ADDENDUM NUMBER 04

**PROJECT: LAUDERDALE COUNTY INNOVATION CENTER
GMC PROJECT NO. ABHM210017**

ADDENDUM #04

Bernhard TME Project No. 12-22-0082
Client Project No. ABHM210017

PARTIAL FLOOR PLANS - COSMETOLOGY PLUMBING
P2.09
Sheet of

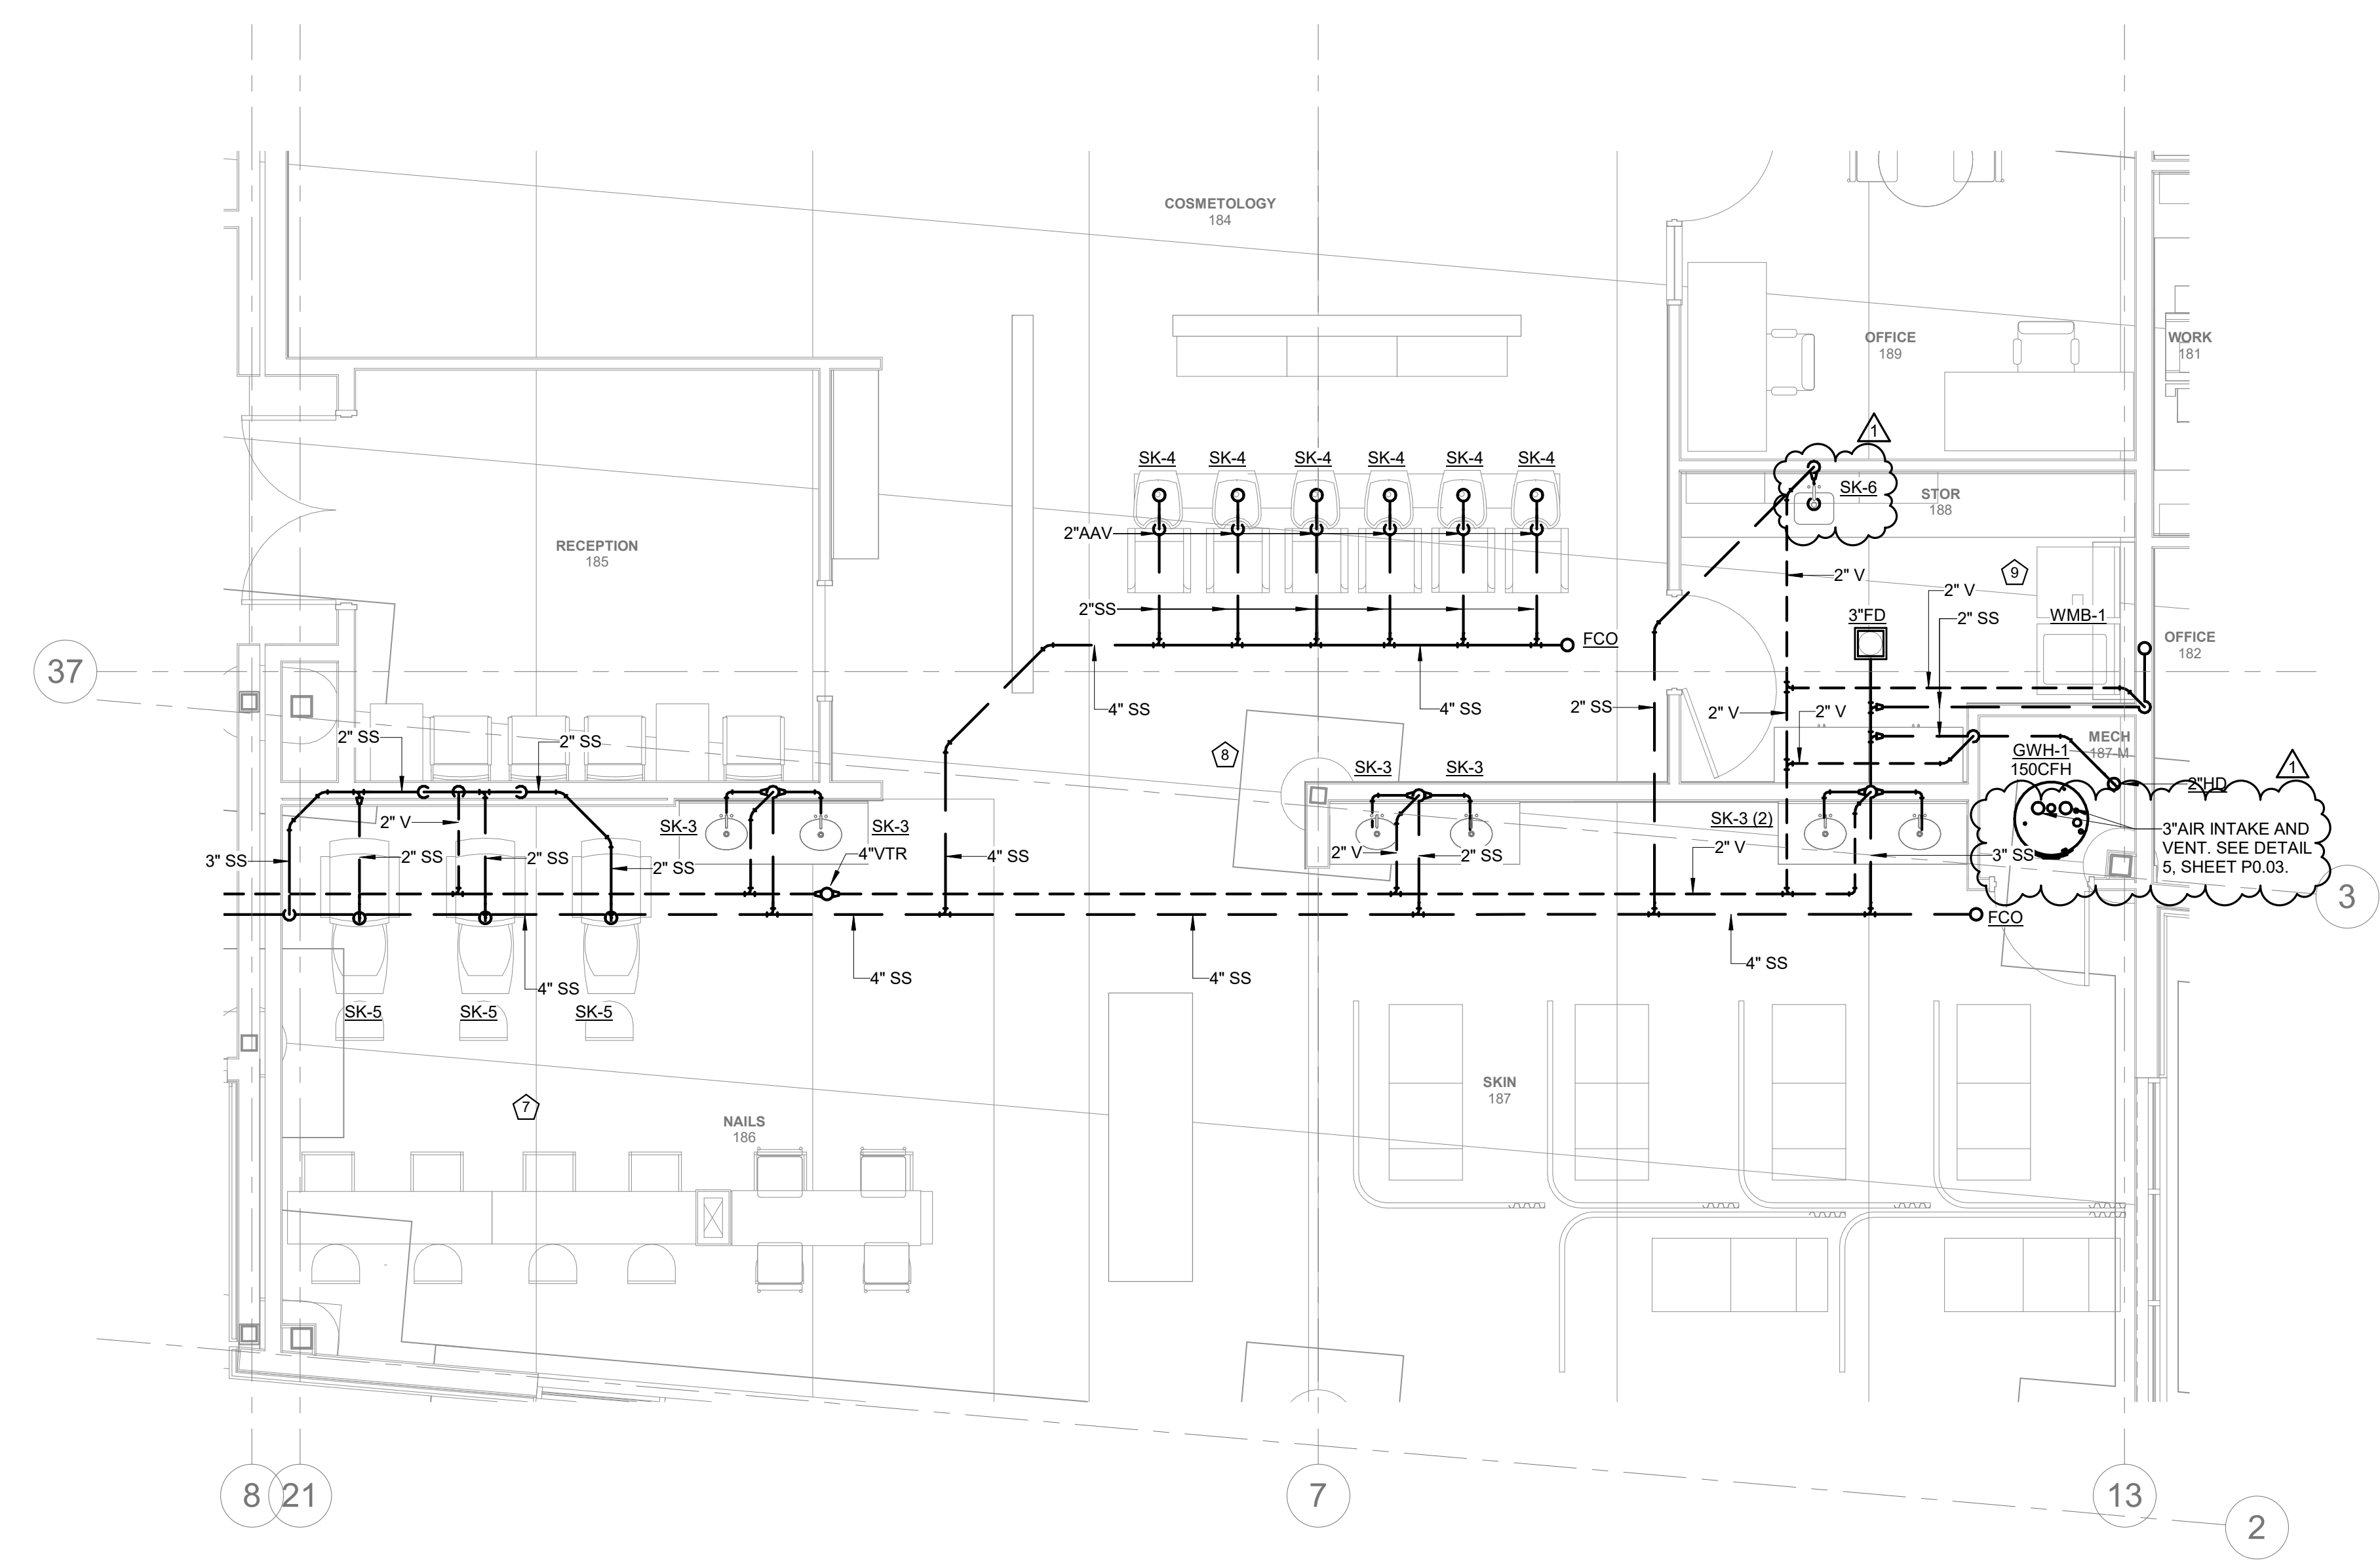
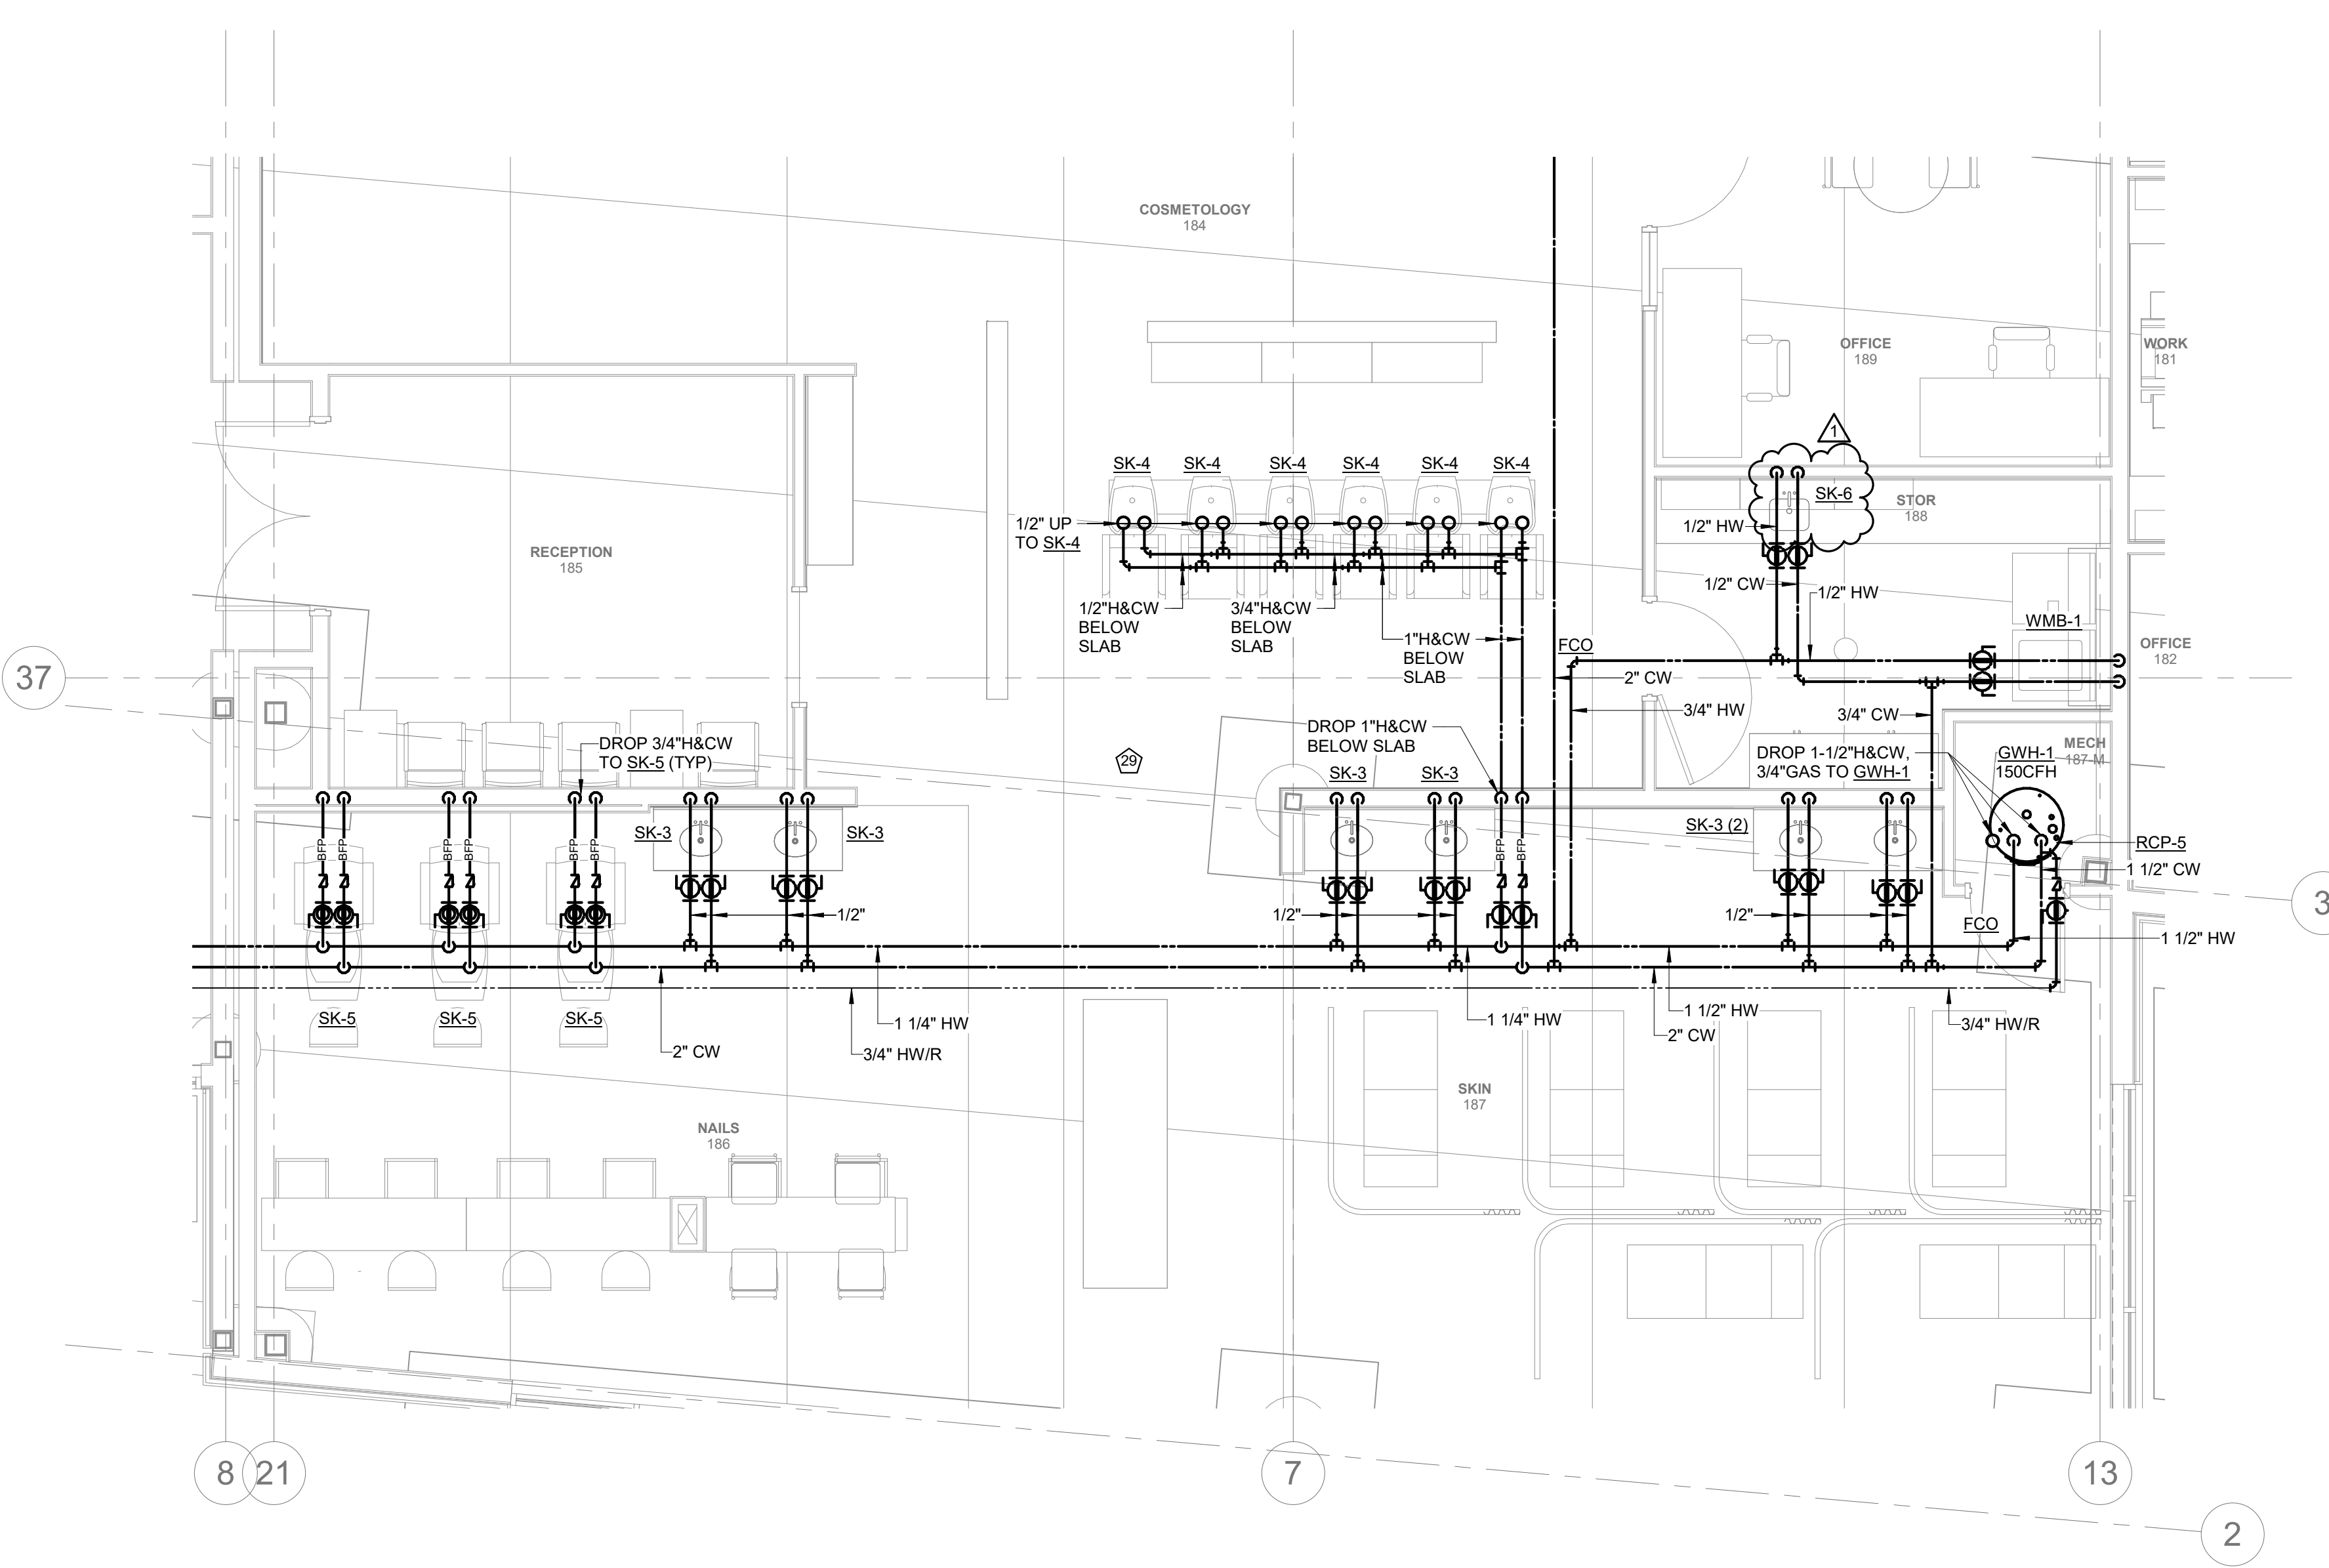
7. Refer to Revised Sheet (P2.09) – (PARTIAL FLOOR PLANS – COSMETOLOGY PIPING) – revision dated (2023-11-03):
 - A. **ADD** 3” air intake and vent.
 - B. **REVISE** Stor 188 sink to SK-6.

3 RISER 08 - COSMETOLOGY 184
SCALE:

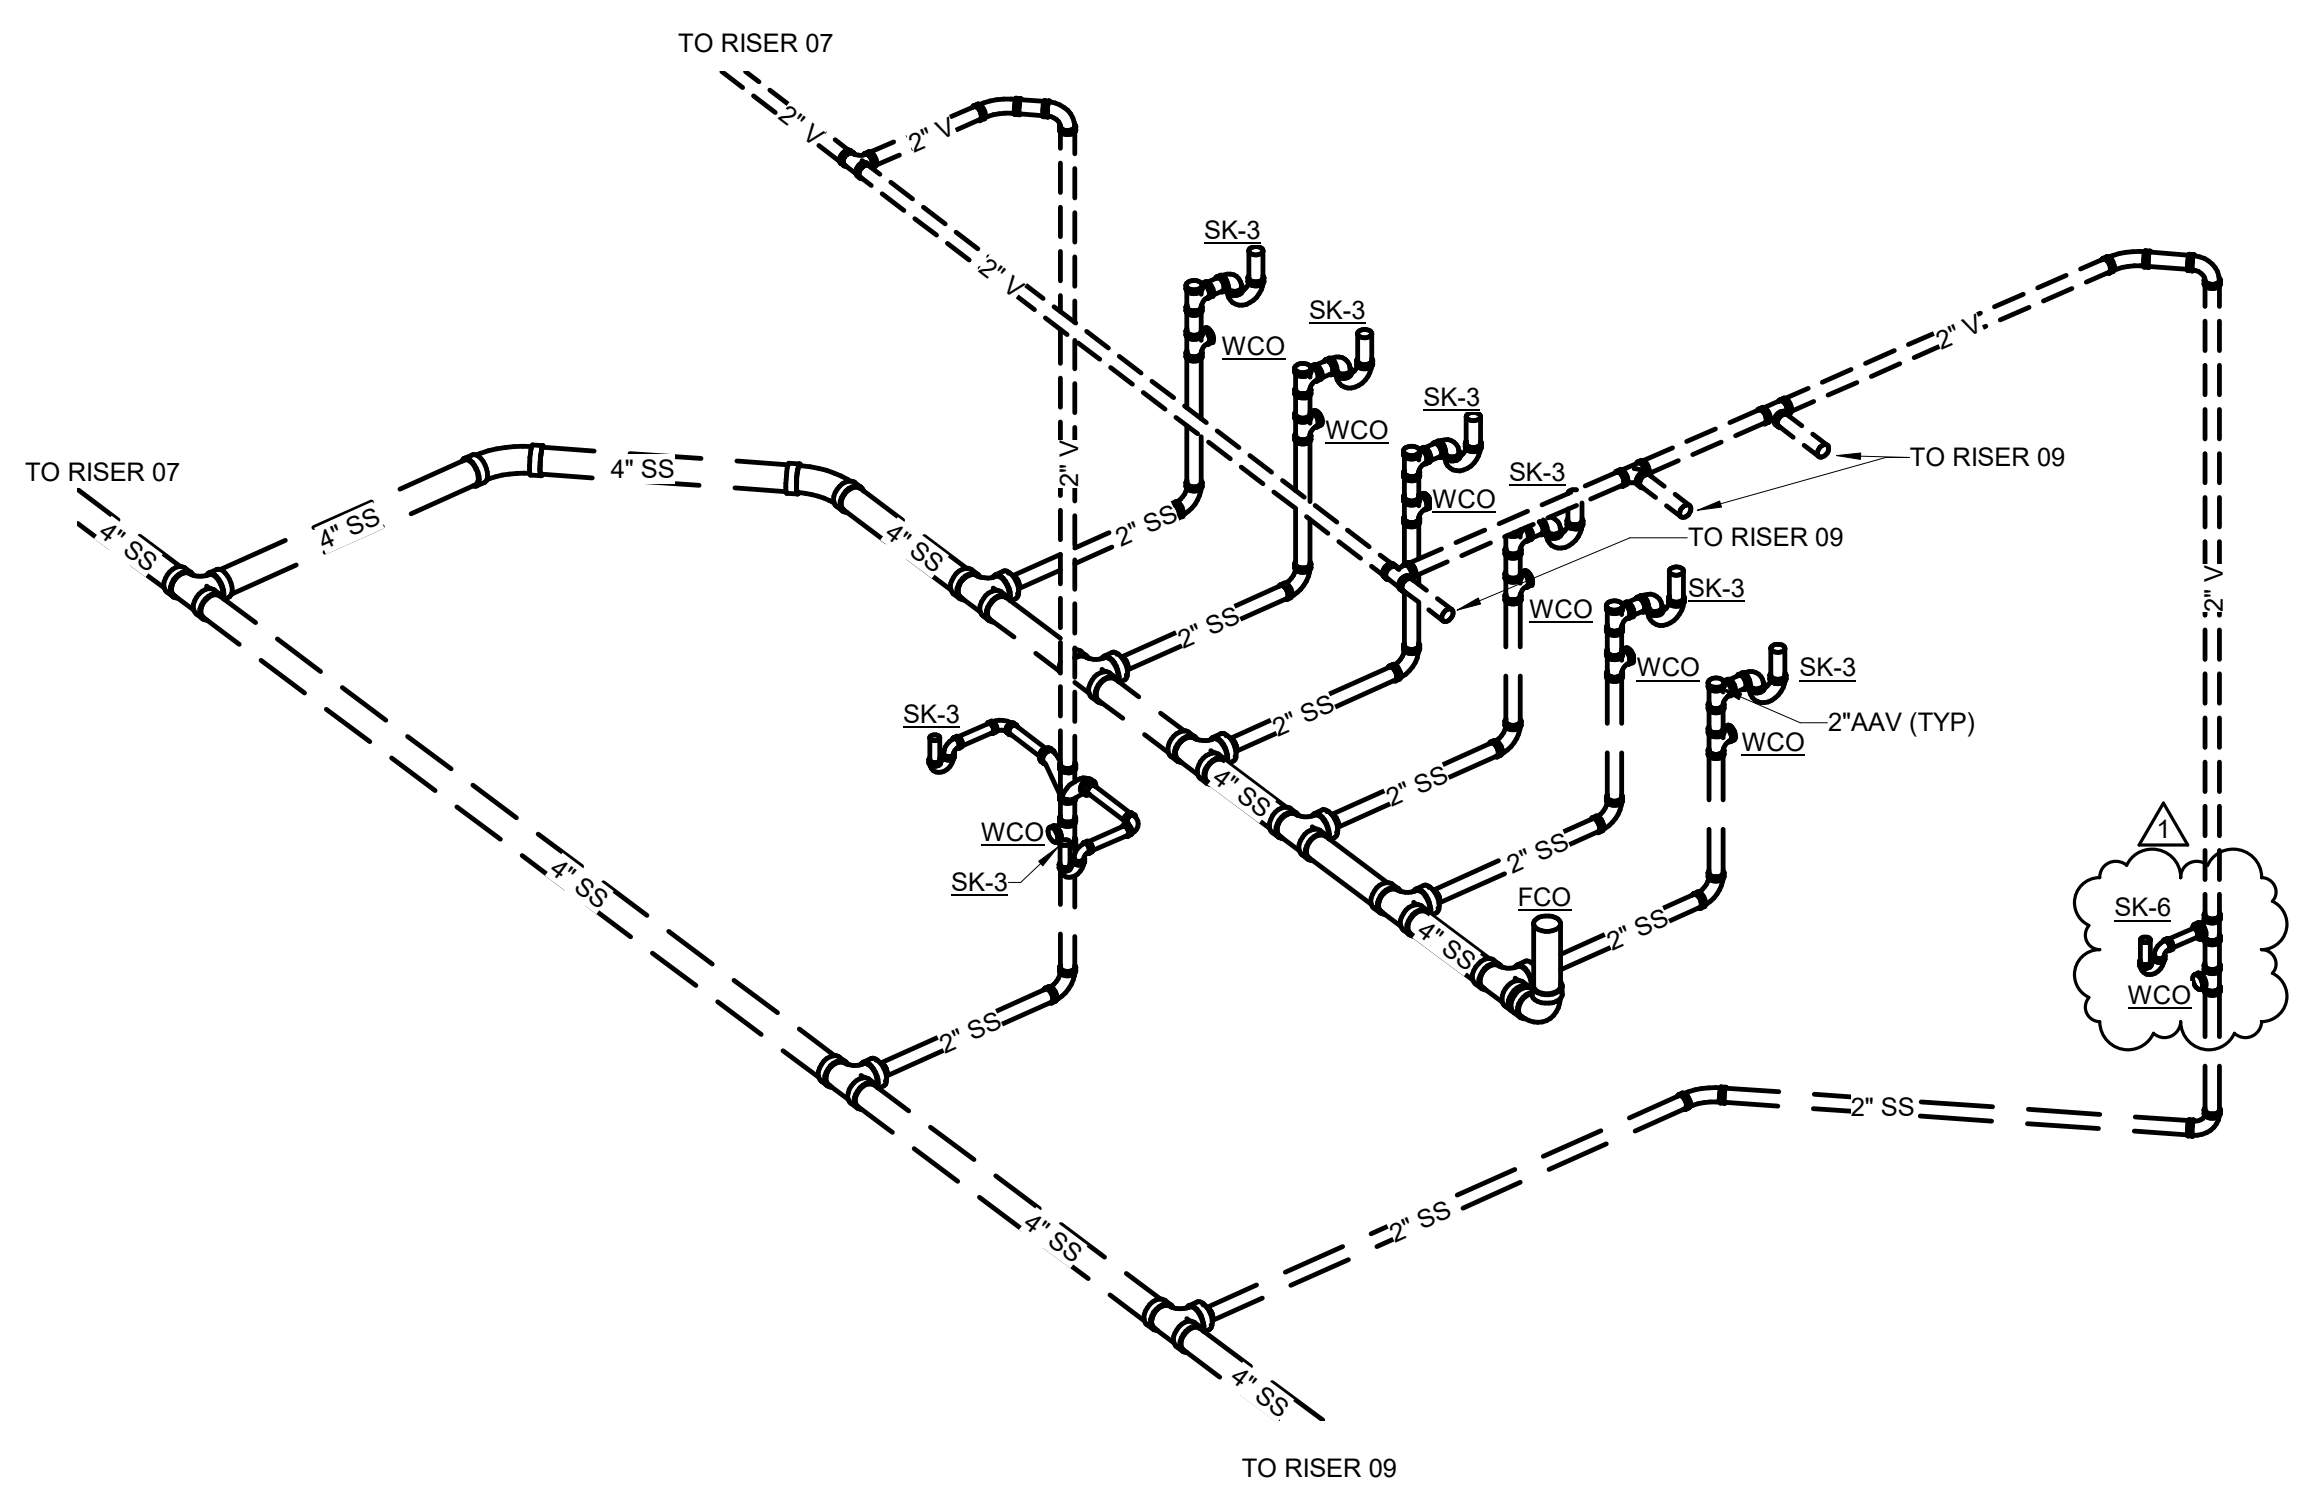
8. Refer to Revised Sheet (P3.02) – (RISERS – SANITARY CONT.) – revision dated (2023-11-03):
 - A. **REVISE** Riser 08.
